Hovey
Industries Ltd.

Field Amendment Notice 12341

SUBJECT:	Leaking thermostat cover, Hovey part number 17320	DATE	Apr 19, 2002
CONCERN:	Nuisance shut downs due to false high limit thermostat alarm.

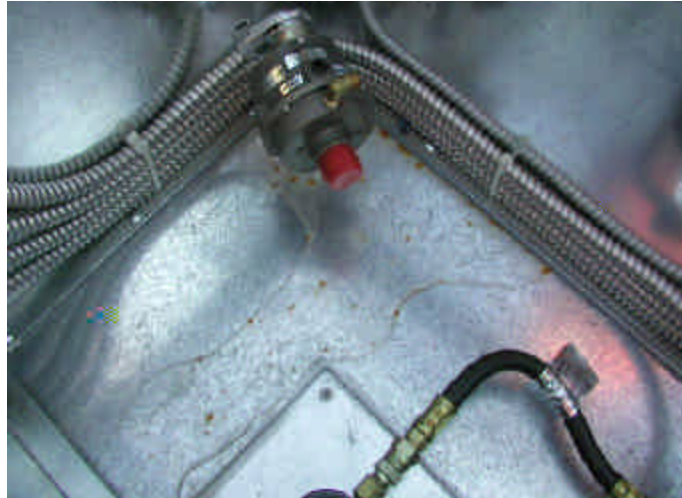
Signs of moisture inside the electrical /gas enclosure, is another indication of the problem. This is caused as a result of moist air travelling up the thermostat conduit and condensing inside.
